METHODS OF RECORD  
AN LWR FUEL ASSEMBLY BURNUP CODE  
AMENDMENT 1  
(NONPROPRIETARY VERSION)  
RESPONSE TO NRC QUESTIONS  
DECEMBER 1983

This amendment to Topical Report NF-1583.02, "Methods of RECORD: An LWR Fuel Assembly Burnup Code," is provided in response to requests for additional information as conveyed by Enclosure 1 of the letter to Mr. E. E. Utley, CP&L, from Mr. Domenic B. Vassallo, NRC Division of Licensing, dated November 1, 1983.

FIGURE 21-1

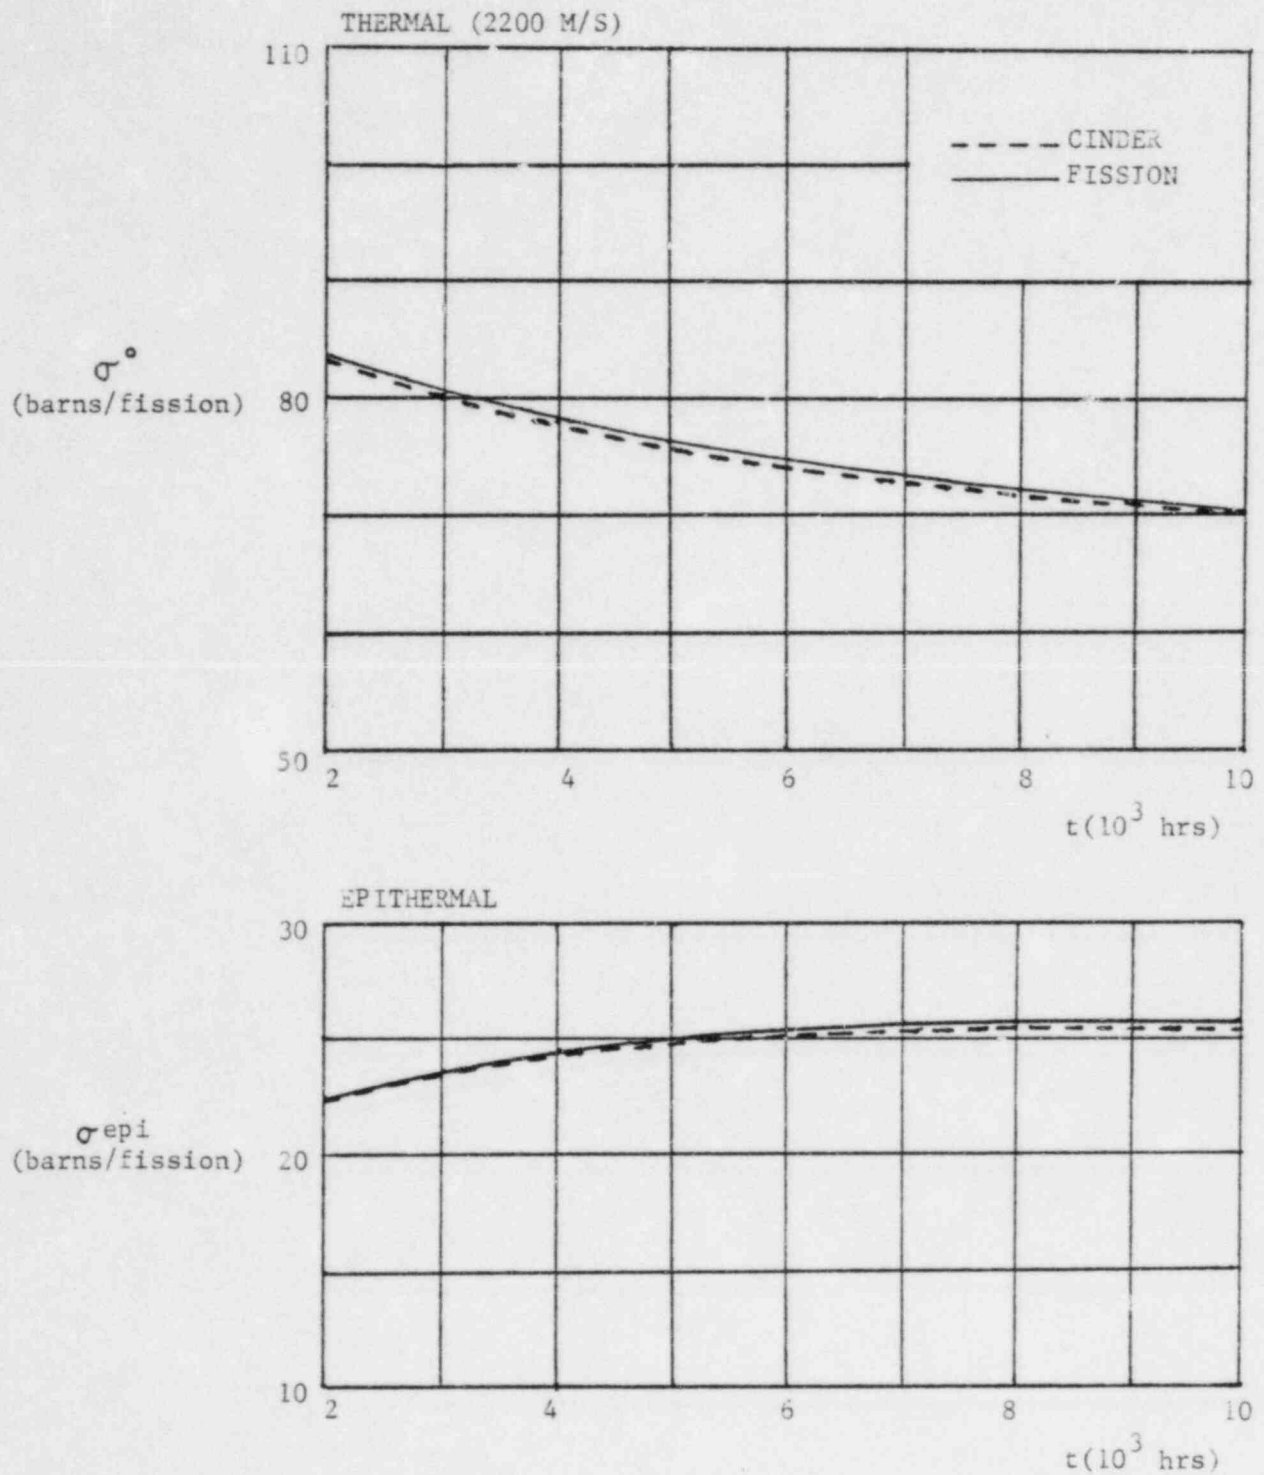
Quantify the statement that the fission product representation chosen for RECORD showed good agreement with the exact representation for burnup to about 30 GWD/TU. In view of the current trend toward higher burnup fuels should this comparison not be extended?

A revised fission product model with 30 explicit isotopes is now being developed for RECORD for high burnup PWR analysis. This new model is expected to yield improved agreement with the fully explicit reference model, both at intermediate and high burnup ( $> 30,000$  MWD/TU). Once the modifications are complete, a study will be performed to determine the adequacy of the present model for high burnup BWR fuel.

A comparison of the reference model with CINDER results is shown in Figure 21.1.

Figure A-1

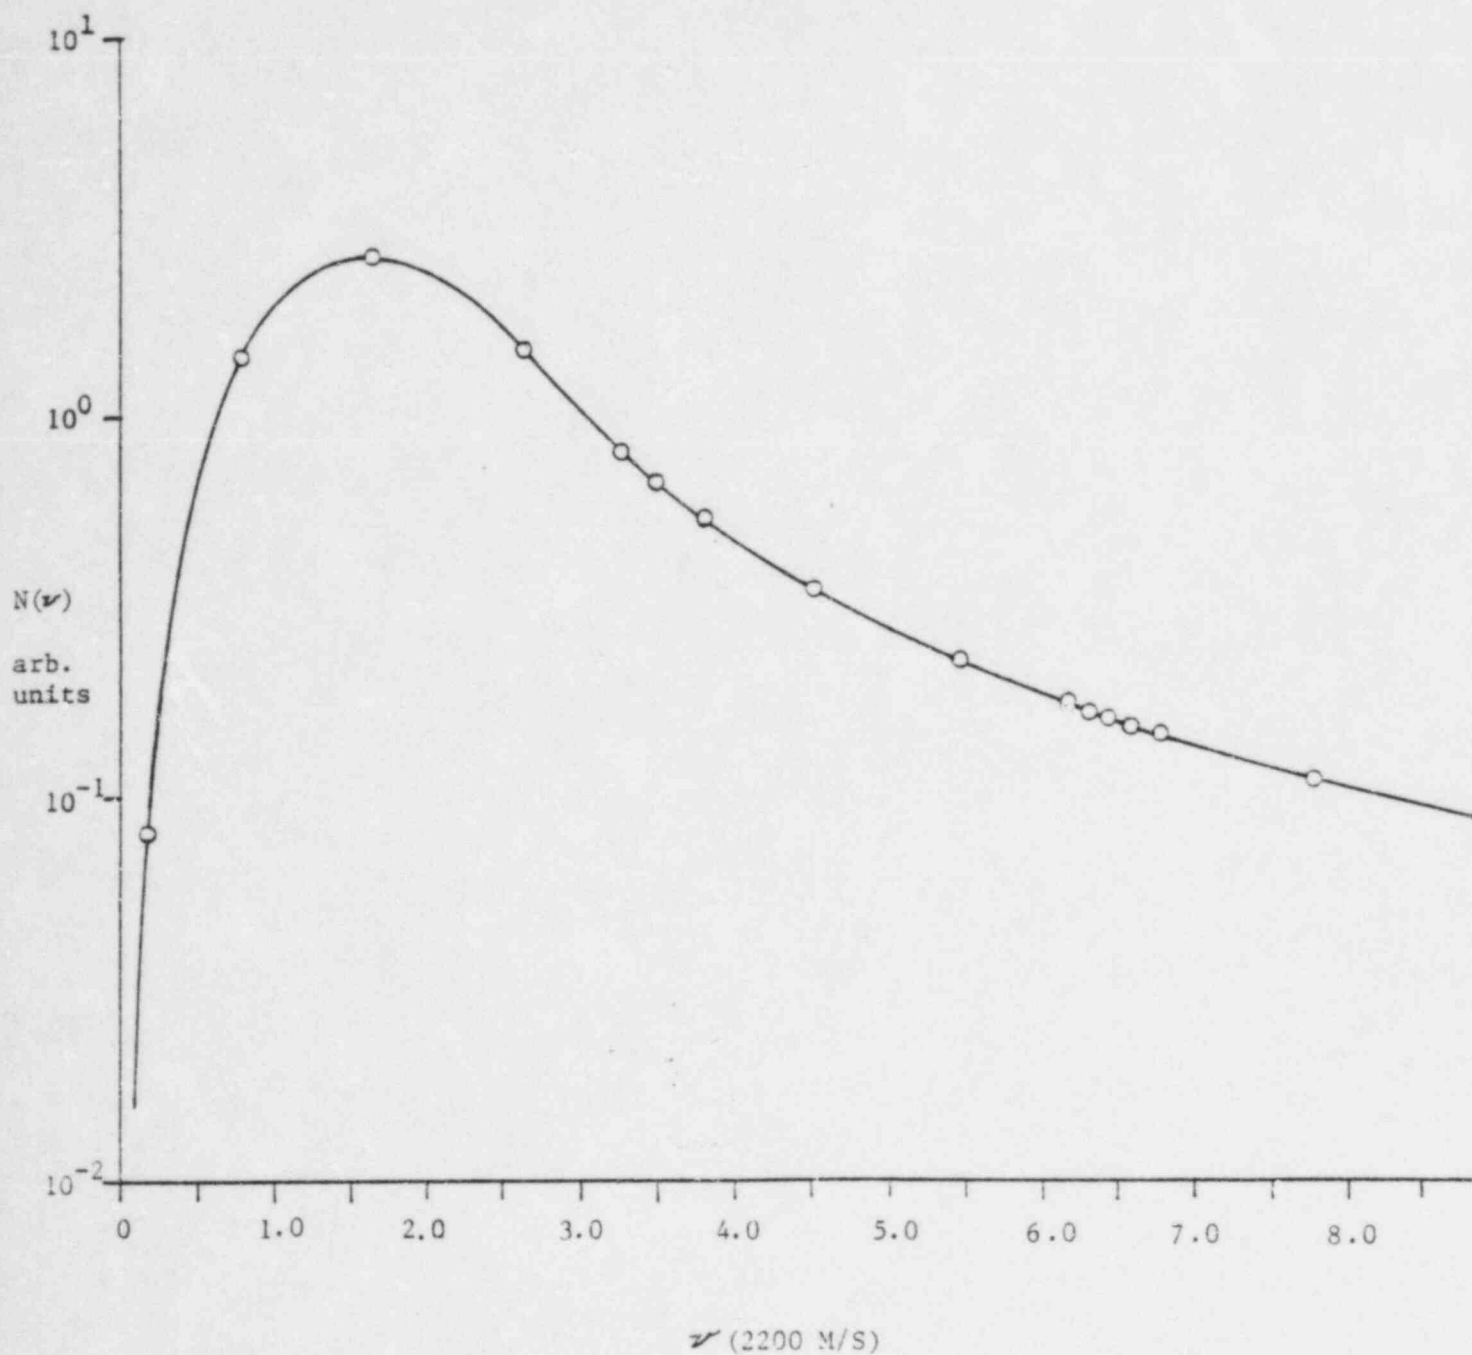
The point energy approach is not described in sufficient detail. In particular more information is needed on the manner in which cross section data are derived from the tabulated 60-180 energy point values in the data library for the determination of the neutron flux at a given energy point value. Similar information is needed with respect to the calculation of the flux disadvantage factors.

The applicability of such a method in RECORD was very much dependent on the possibility for obtaining required accuracy with a reduced number of velocity points. A comparison of a calculated thermal neutron spectrum in a homogenized BWR fuel pin cell, using different numbers of velocity points at zero and 40,000 MWD/TU, is shown in Figures A-1 and A-2.

Our conclusion is that application of 15 energy (or velocity) points in RECORD, using the "Point Energy Approach", gives the required accuracy.
